CHANGE ORDER

No. 01

Project: Montz Pump Station No. 1

You are directed to make the following changes in the Contract Documents:

Amps X 10 3000 GEN (Nom. kV=0.48, Plot Ref. kV=0.48)

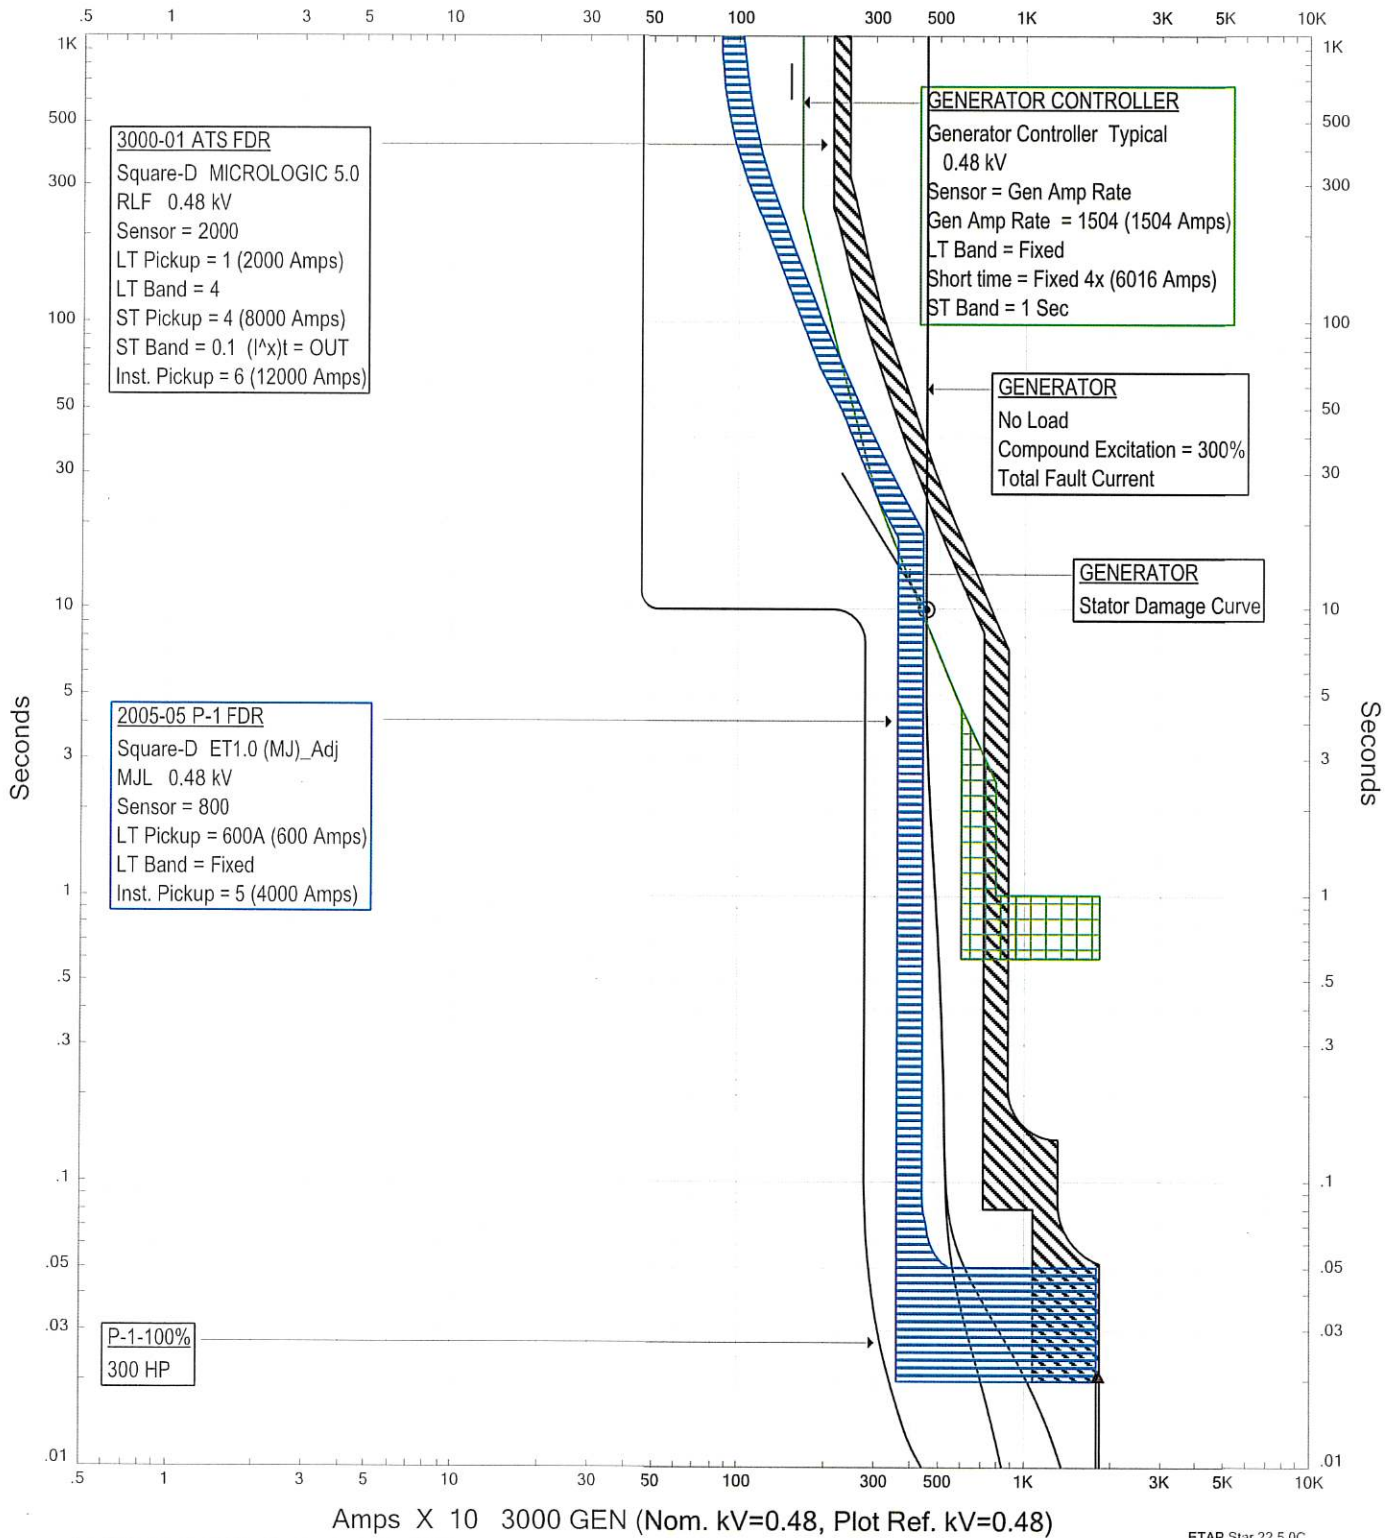
Revise the four (4) pump soft starter breakers from M-frame to L-frame breakers to add the adjustable time delay function necessary for proper coordination with the main generator breaker. The generator breaker is outside of SqD's scope and therefore coordination could not be confirmed prior to the bid.

The initial coordination study included M-frame breakers that meet the MCC specification (see below & attached), but the revised study requires additional functionality beyond what was specified to achieve proper coordination.

Our MCC for this project was quoted with “soft starts” that included our “standard” UL rated thermal-magnetic M-frame MCCB. Due to coordination study factors that were out of Schneider Electric’s control, The study findings requested we change the “standard” UL rated M-frame soft start breaker to a “LJ” electronic trip “LI” breaker to meet the current coordination study needs. We contacted our plant to verify if the “LJ” breaker would still comply with the UL rating of the soft start, which they verified it would. This change of breaker request has resulted in our change order #4. Please let me know if you have any other questions or concerns.
